Access Compliance Report

Public Rights-of-Way

(Curb Ramps)

Intersection ID: N/A	Main Street: WOODLAWN_RD	Cross Street: N/A	Location: SE
ADA ID: C8D6DDC6ADEB	Ramp Type: PerpDiag	Initial Pass/Fail: Fail	Overall Compliance: No
		Severity Score: 25

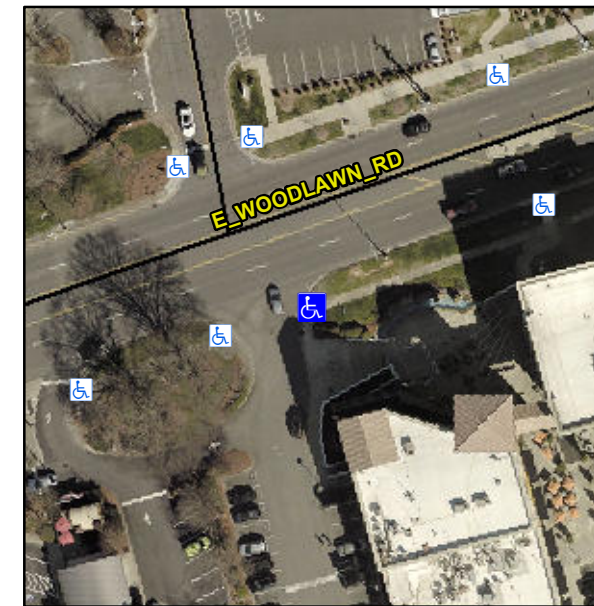
Not Found, R304.5.3

Compliance	Description	Data	Compliance	Description	Data
N/A	Ramp Length (in)	84.0	Yes	Ramp Slope (%)	5.3
Yes	Ramp Width (in)	52.0	No	Ramp XSlope (%)	8.0
N/A	Flare Type LT	N/A	N/A	Flare Type RT	N/A
N/A	Flare Slope LT (%)	N/A	N/A	Flare Slope RT (%)	N/A
N/A	Flare Traversable LT?	N/A	N/A	Flare Traversable RT?	N/A
N/A	Landing Length (in)	N/A	N/A	DWS Provided?	N/A
N/A	Landing Width (in)	N/A	N/A	DWS Contrast?	N/A
N/A	Landing Slope (%)	N/A	N/A	DWS Length (in)	N/A
N/A	Landing X Slope (%)	N/A	N/A	DWS Full Width?	N/A
N/A	Landing Curb? (Y/N)	N/A	N/A	DWS Offset (in)	N/A
N/A	Shared Landing?	N/A			
N/A	Gutter Ponding?	N/A	N/A	Gutter Slope (%)	N/A
N/A	Gutter Lip Ht (in)	N/A	N/A	Gutter X Slope (%)	N/A
N/A	Painted X Walk1?	No	N/A	Painted X Walk2?	No
	X Walk 1 Direction	To N		X Walk 2 Direction	To W
N/A	X Walk 1 Width (in)	N/A	N/A	X Walk 2 Width (in)	N/A
	X Walk 1 Slope (%)	6.2		X Walk 2 Slope (%)	3.0
	X Walk 1 X Slope (%)	2.4		X Walk 2 X Slope (%)	7.7

Remove & Replace Curb Ramp With Two New Directional Ramps or Equivalent.
